Contract #: 04-0120F4Cty: SF/ALA Rte: 80 PM: 13.2/13.9File #: 69.25B**QUALITY ASSURANCE -- NON-CONFORMANCE REPORT****Location:** Changxing Island, Shanghai, PRC**Report No:** NCR-000276**Prime Contractor:** American Bridge/Fluor Enterprises, a JV**Date:** 25-May-2009**Submitting Contractor:** Zhenhua Port Machinery Company, Ltd (ZPMC), Changxing Island**NCR #:** ZPMC-0250**Type of problem:**

Reference Description: West Tower, Lift 3, Skin C linear indication**Description of Non-Conformance:**

Reference Description: Linear Indication / West Shaft Lift 3 Skin C / Intermediate Stiffener to Longitudinal Stiffener Weld

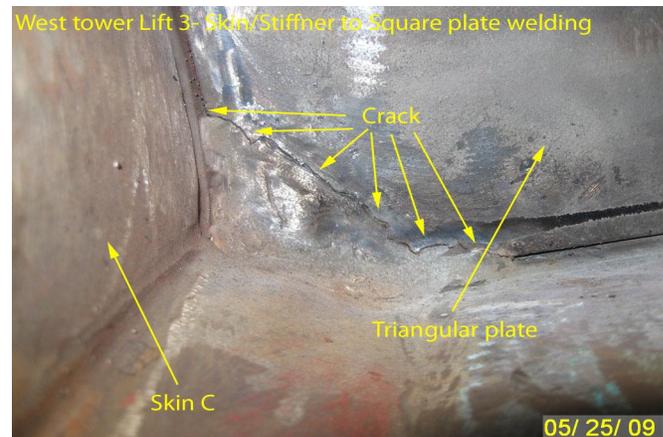
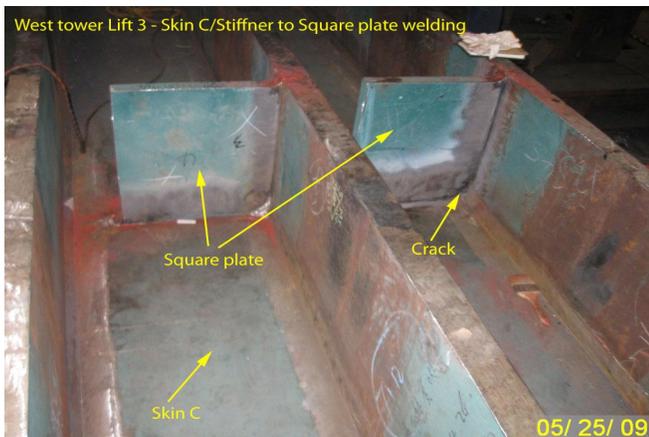
During random verification of West Tower, Lift 3, Skin C welds, QA discovered a linear indication at the toe of fillet weld WSD1-FCSA3-2C/C-3,4. This weld was previously tested and accepted by ZPMC personnel.

AWS D1.5-2002 Section 6.26.1.1 "The welds shall have no cracks."

Section 6.26.1.2 "Thorough fusion shall exist between adjacent layers of weld metal and between weld metal and base metal."

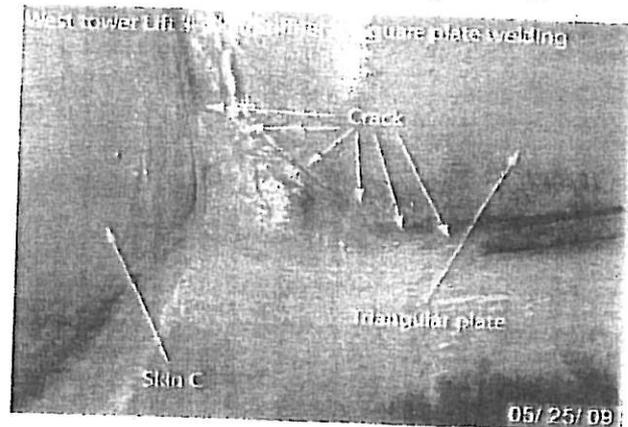
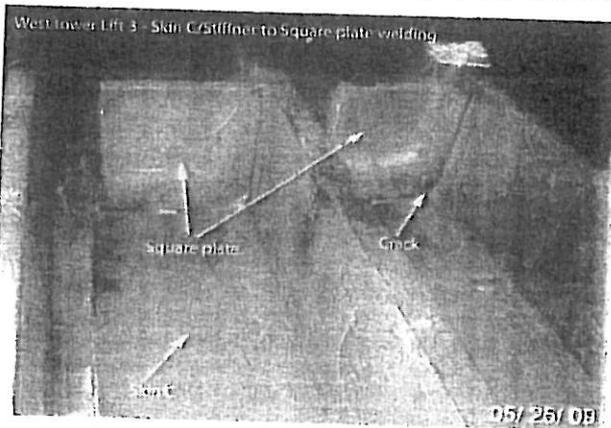
During random verification of West Tower, Lift 3, Skin C welds, QA discovered a linear indication at the toe of fillet weld WSD1-FCSA3-2C/C-3,4. This weld was previously tested and accepted by ZPMC personnel.

AWS D1.5-2002 Section 6.26.1.1 "The welds shall have no cracks."

Section 6.26.1.2 "Thorough fusion shall exist between adjacent layers of weld metal and between weld metal and base metal."

Description of welding discontinuity:

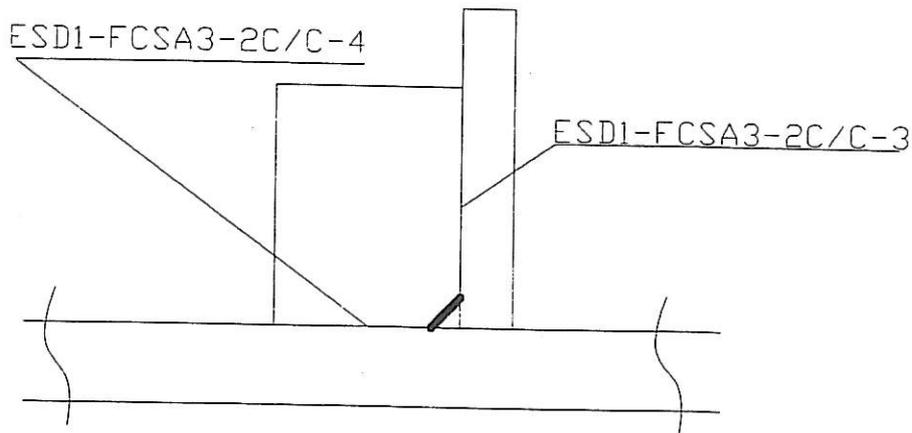
The linear defect was found at weld WSD1-FCSA3-2C/C-3,4 of west tower Skin C stiffener, the detail sees the following draft.

注:阴影部分为缺陷位置 Remark: defect position in shadow.

1. QC shall verify sufficient preheat has been applied, to remove moisture, prior to welding.

1. QC shall monitor gouging/grinding/welding
2. Gouge defects & grind smoothly
3. Verify that defects have been removed with VT
4. Welding shall be in accordance with WPS
5. QC shall ensure all slag is removed prior to deposition of subsequent weld passes
6. Blend repair area with adjacent base metal
7. Perform VT, MT, & UT to repaired area

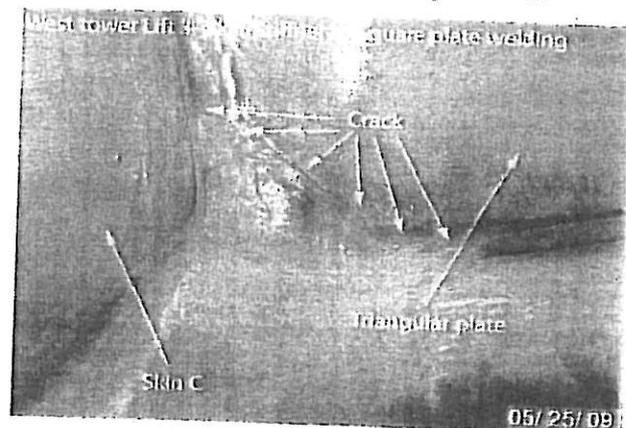
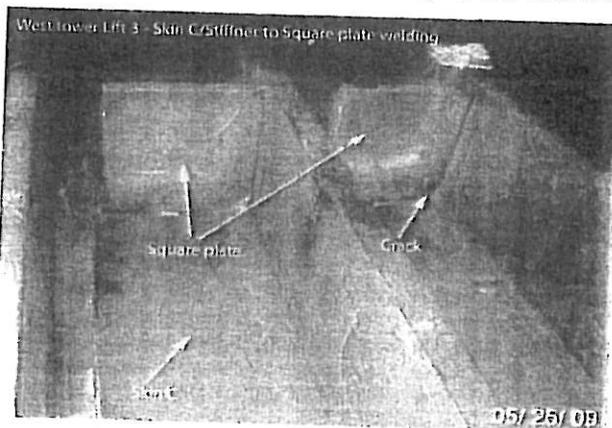
During random verification of West Tower, Lift 3, Skin C welds, QA discovered a linear indication at the toe of fillet weld WSD1-FCSA3-2C/C-3,4. This weld was previously tested and accepted by ZPMC personnel.

AWS D1.5-2002 Section 6.26.1.1 "The welds shall have no cracks."

Section 6.26.1.2 "Thorough fusion shall exist between adjacent layers of weld metal and between weld metal and base metal."

Description of welding discontinuity:

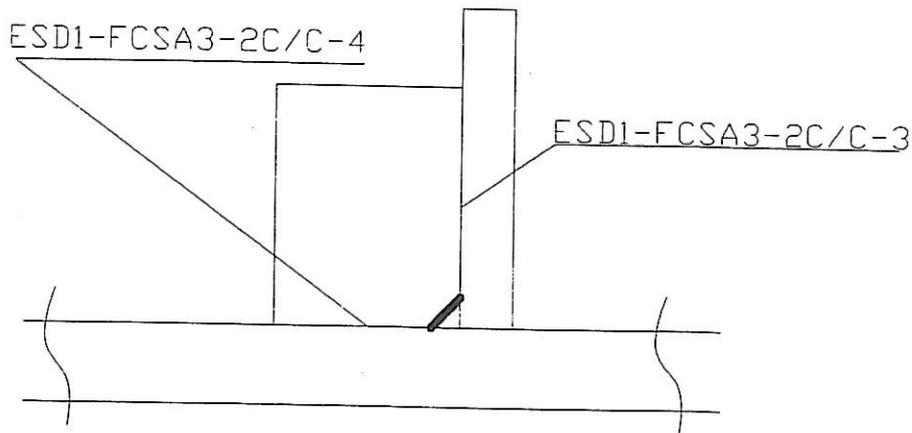
The linear defect was found at weld WSD1-FCSA3-2C/C-3,4 of west tower Skin C stiffener, the detail sees the following draft.

注:阴影部分为缺陷位置 Remark: defect position in shadow.

1. QC shall verify sufficient preheat has been applied, to remove moisture, prior to welding.

1. QC shall monitor gouging/grinding/welding
2. Gouge defects & grind smoothly
3. Verify that defects have been removed with VT
4. Welding shall be in accordance with WPS
5. QC shall ensure all slag is removed prior to deposition of subsequent weld passes
6. Blend repair area with adjacent base metal
7. Perform VT, MT, & UT to repaired area
